Addendum to the  
Environmental Impact  
Assessment Report

**NISA**  
*North Irish Sea Array*

# Appendix A10.2

## Marine Physical Processes Numerical Modelling

Figure A4.5: Time-series comparison of modelled and measured depth-average current directions, Site A (replaces Figure 4.11 in Appendix 10.2 of the 2024 EIAR).

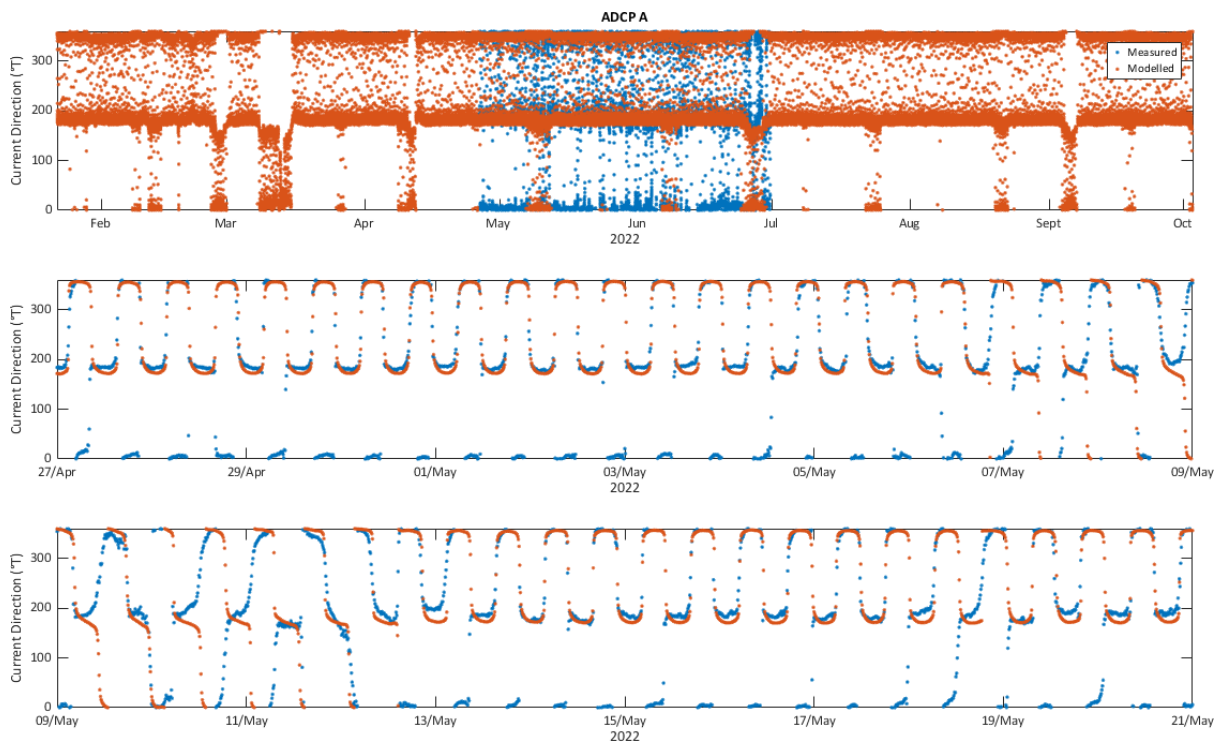
7 (b)	The labels on the directional plots on Figures 4.11 and 4.13 within Chapter 10 of the EIAR are incorrect. The applicant is requested to address this issue.	The labels on the directional plots on Figures A4.5 and A4.6 in A10.2 have been corrected as requested.
7 (c)	The applicant is requested to submit time series plots comparing simulated wave events relative to recorded wave buoy data including direction, period and wave height or water surface elevation (WSE).	Time series plots comparing simulated wave events have been provided in in Section 5.4 of Appendix A10.2.
7 (d)	The modelling undertaken in support of Chapter 10 of the EIAR does not demonstrate spatial variation of bed friction or bed shear stress values across the model domain. The	Confirmation of the modelling utilising a spatially-varying bed roughness across the model domain is provided in Section 4.3 of Appendix A10.2.

The changes in this section are additional figures provided in response to RFI Sections 7 (a) and 7 (b). Figures A4.1 to A4.4 illustrate the comparison of measured and modelled depth-average currents, for Sites A and B, during neap and spring tidal periods. Figure A4.5 and Figure A4.6 replace Figures 4.11 and 4.13 in Appendix 10.2 of the 2024 EIAR respectively with corrected labels.

Figure A6.1. Locations used in particle tracking modelling (replaces Figure 6.1 in Appendix 10.2 of the 2024 EIA).

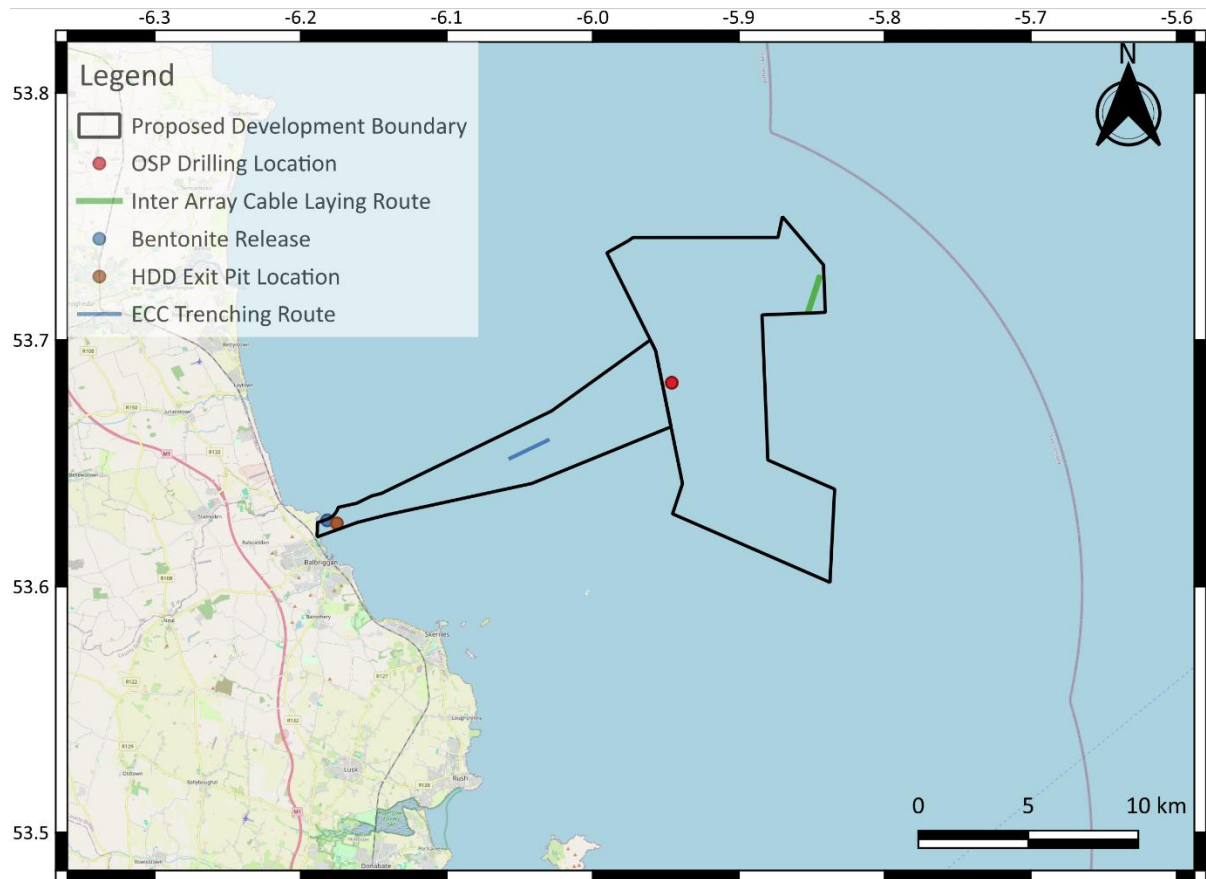
The geographical positions of each of the sediment release locations described below are shown in Figure A6.1. In each case, these locations are associated with the highest concentration of fine sediments in the seabed which are expected to lead to the largest suspended sediment concentrations within the short-term duration of plume

Figure 6.1 in Appendix 10.2 of the 2024 EIA shall be deleted and replaced with Figure A6.1, illustrating updated particle tracking release locations.
